RFP Title: Trinity Square Area Water Main Rehabilitation

ADDENDUM NO. 3

RE: TRINITY SQUARE AREA WATER MAIN REHABILITATION
CONTRACT NO. 8-23

AREA PLAN 1
 PROJECT NO. 1516-274596
 FILE NAME: C001PLPR.DWG
 SHEET NO. **C-1**

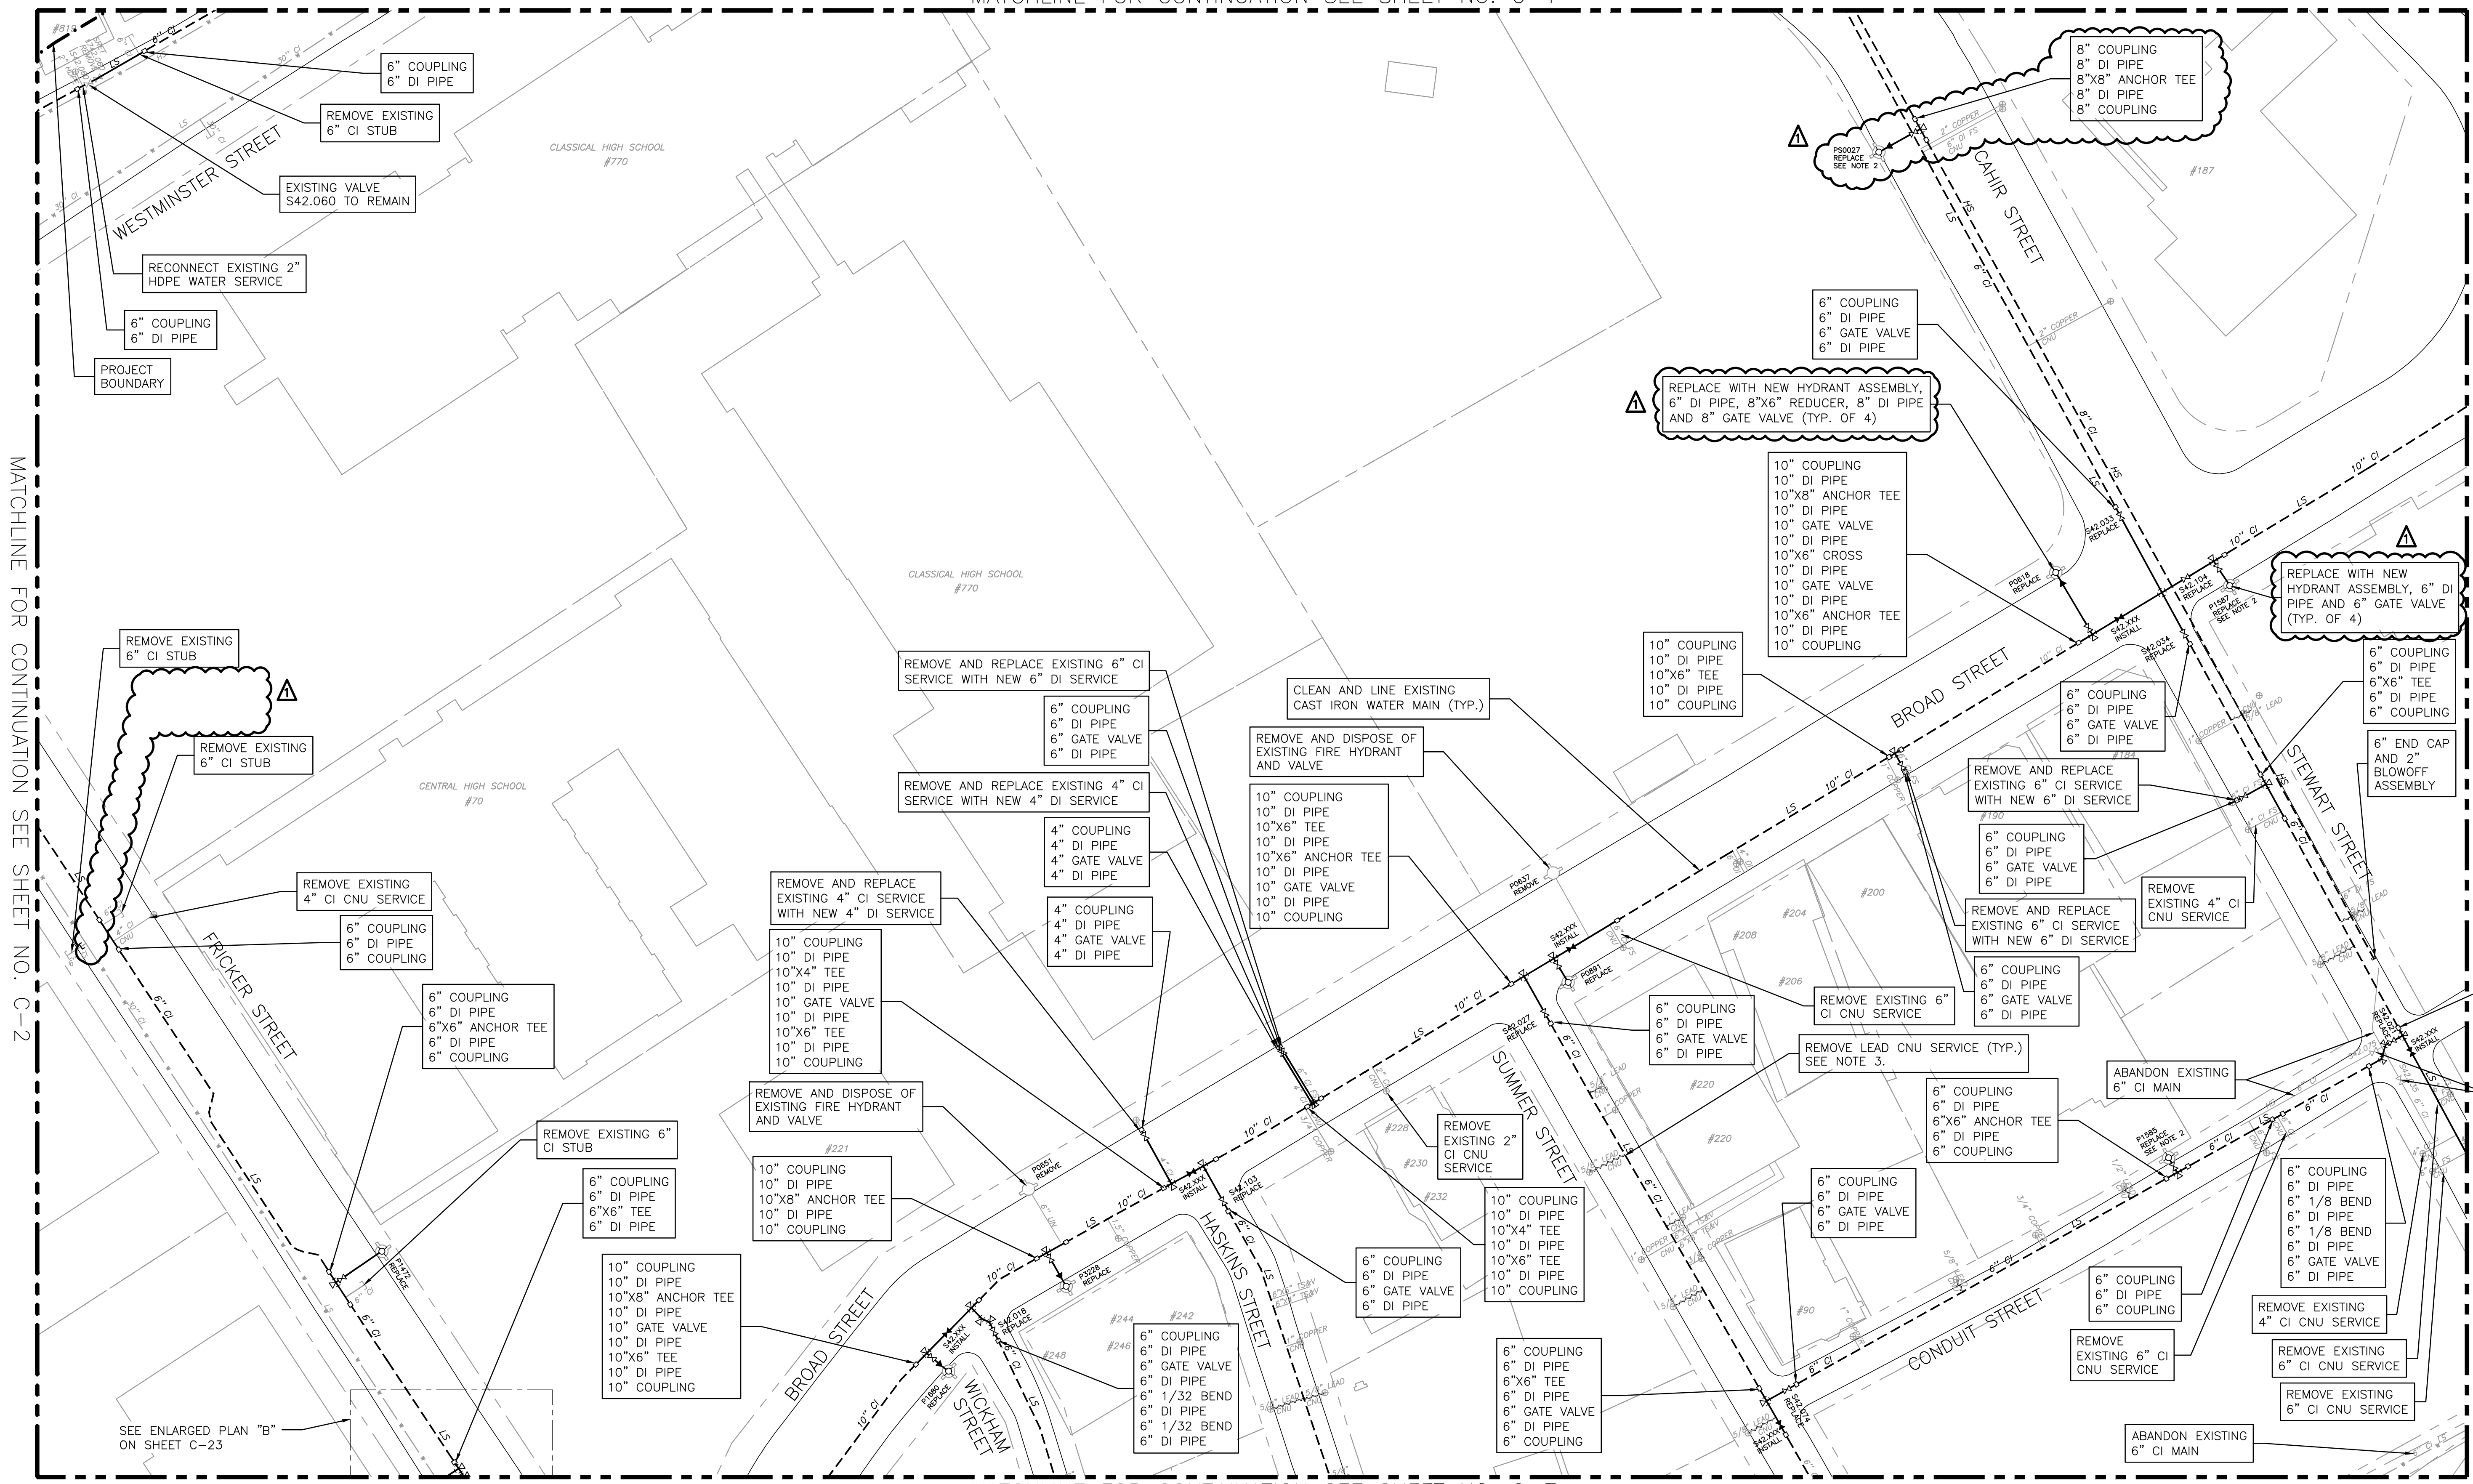
14. QUESTION: There are several locations that call for removal of 30 inch tees for sidelines, and installation of 30 inch tees for hydrants (C-1 & C-7), but the bid items only pay for 6, 8, 10, and 12 inch Ductile Iron pipe. There is no item for 16, 20, or 30 inch Ductile Iron Pipe. Please clarify how the contractor is to be reimbursed for the work to install these short segments.

27. QUESTION: Your response to question 10 states that we will be responsible for capping or plugging the tees only and not removing them. Just to clarify, on sheet C-1 Westminster St. @ #7000, do we cap the 30" tee or remove it? Still on Westminster St on the 16" main between #700 & #674, do we cap the 16" tee or remove it? On C-18 Blackstone St. @ #344 on the 16" main, do we cap the tee or remove it? We just want to be clear on those.

RESPONSE: Please see Response to Question 3.

RESPONSE: See the Response to Question 11.

AREA PLAN 3
 PROJECT NO. 1516-274596
 FILE NAME: C001PLPR.DWG
 SHEET NO. C-3

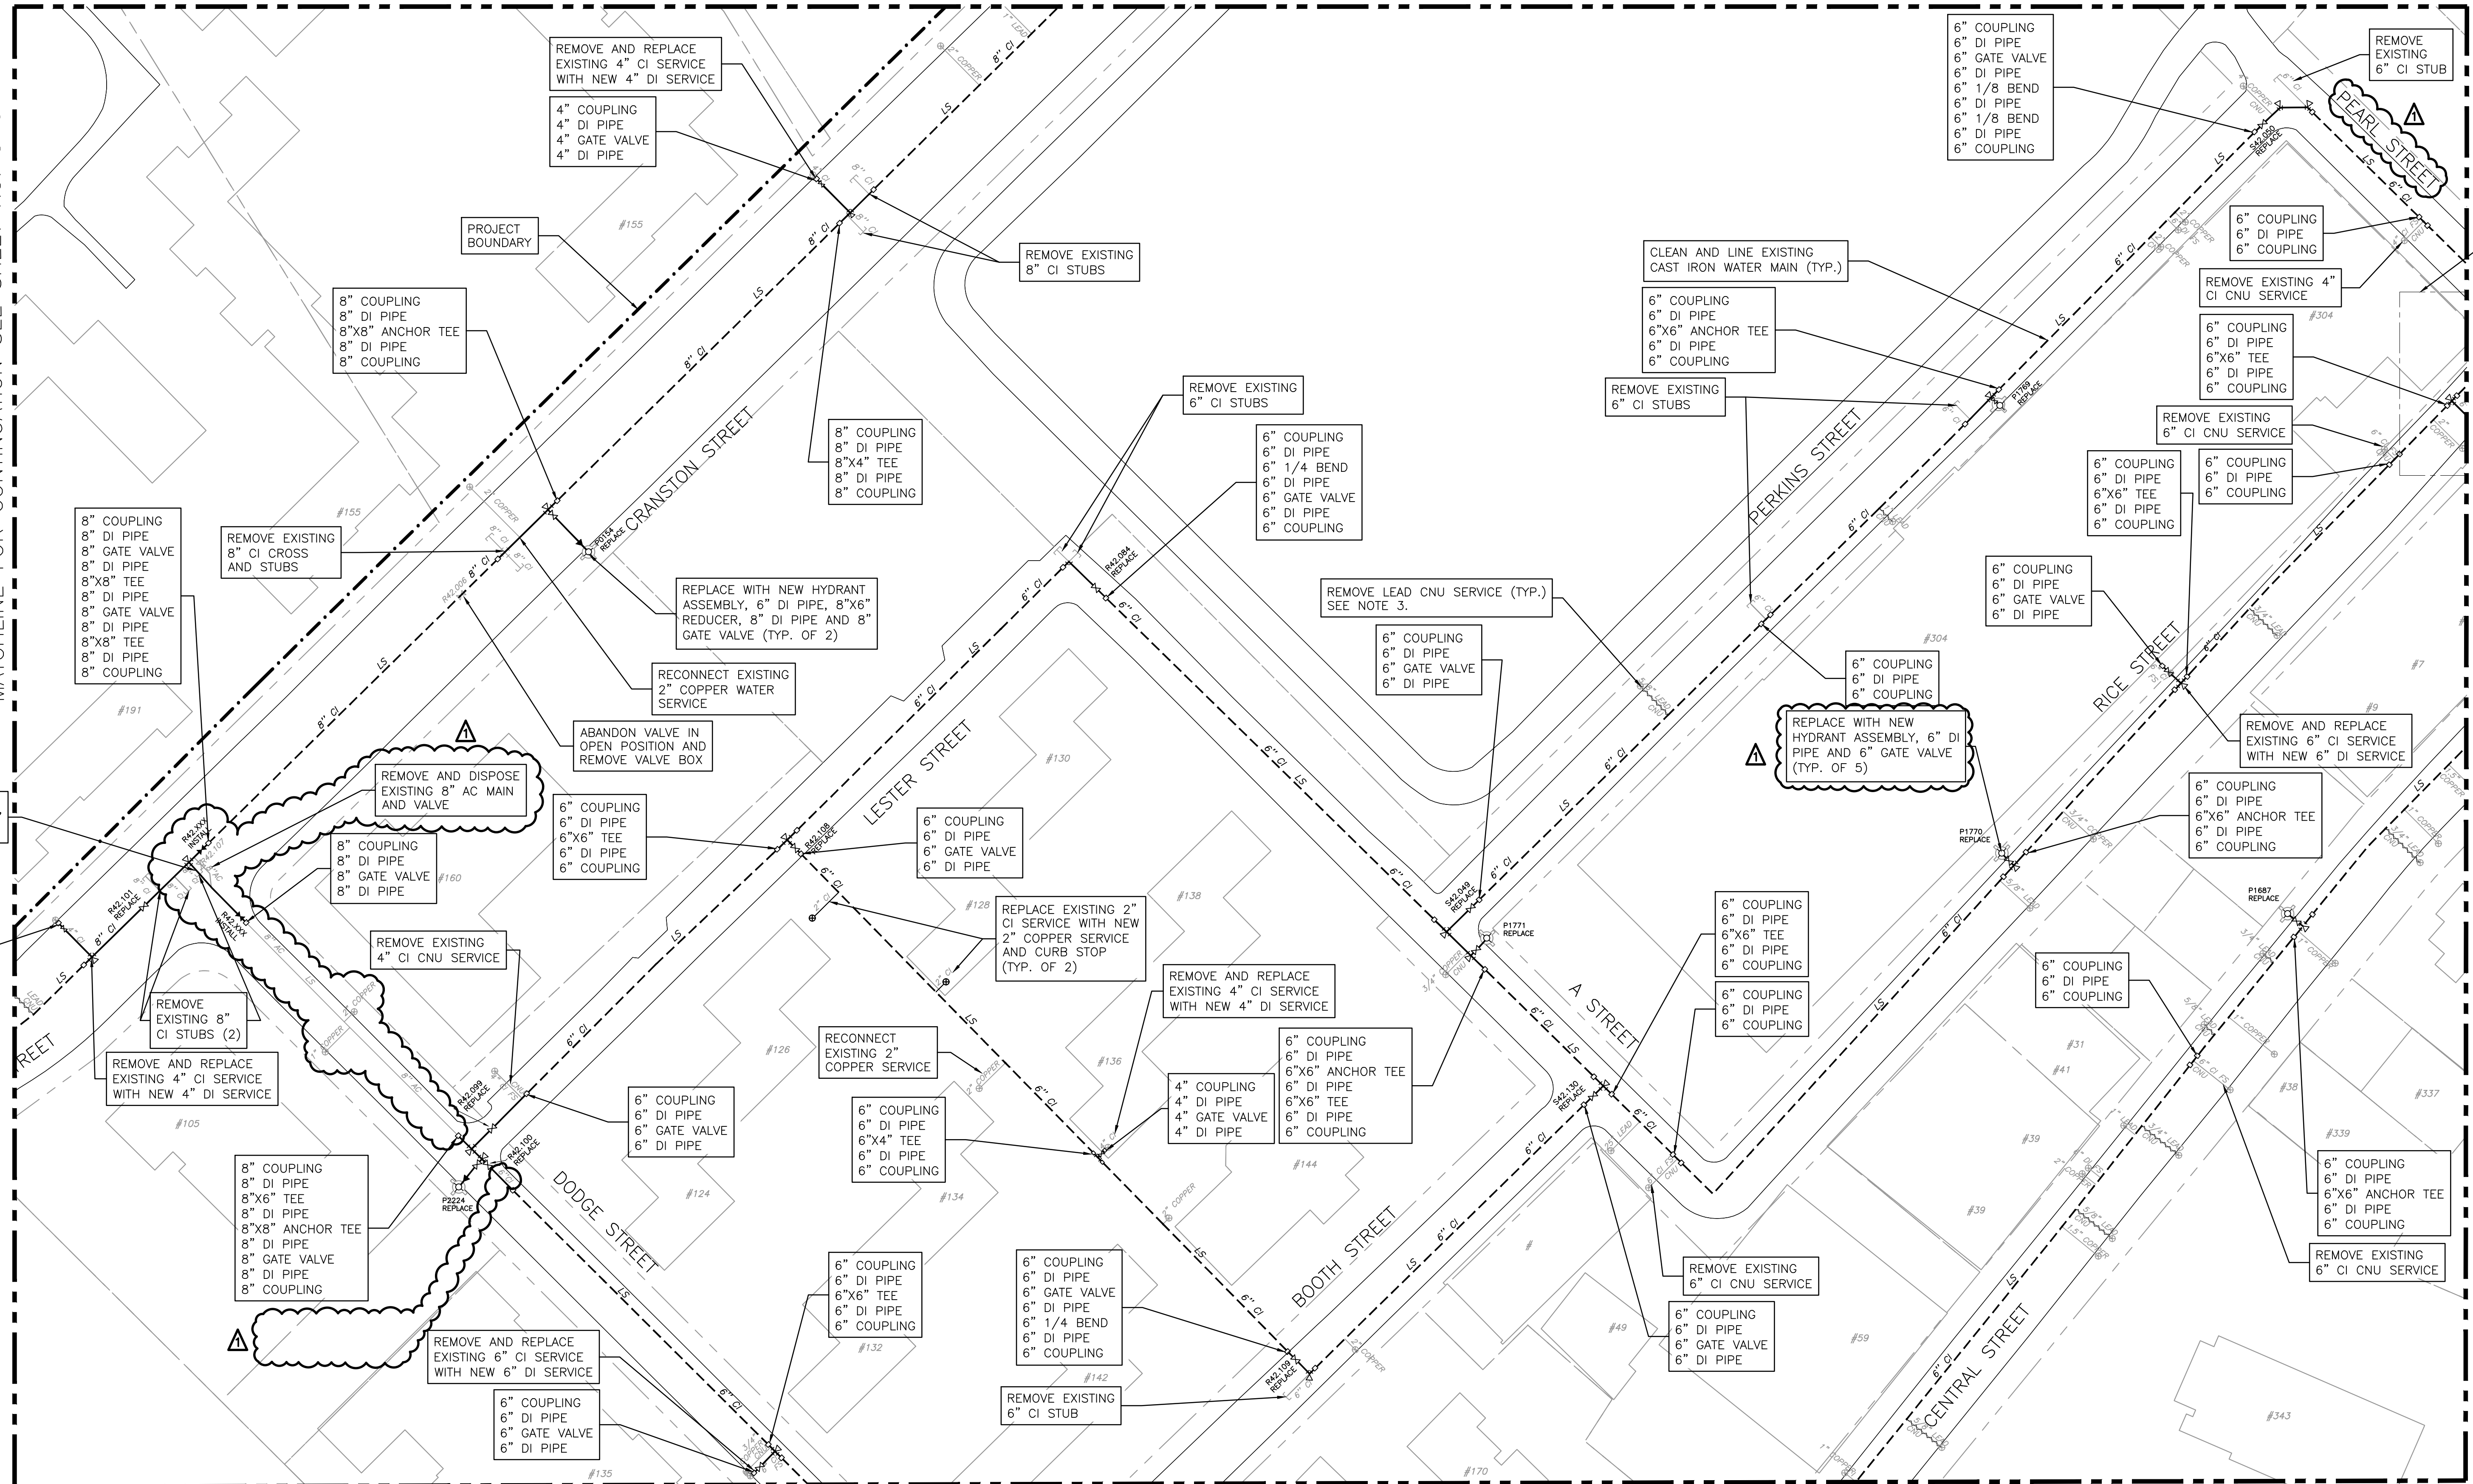
29. QUESTION: Your response to question #9 states that laterals over 10' long will be 8" in diameter. This doesn't make much sense to us. For example, on Sheet C-3 on Fricker Street @hydrant P1472, the 6" hydrant lateral is 20' long. Will the contractor be expected to install a 6"x6"x6" tee, 6" gate valve, 6"x8" reducer, 20' of 8" DIP pipe, back into another 6"x8" reducer, only to connect back into the 6" MJ on the fire hydrant? I assume this is only for mains 8" and great. Please clarify this is what is to be expected.

RESPONSE: See the updated Contract Drawings in Attachment No. 3 of Addendum No. 3.
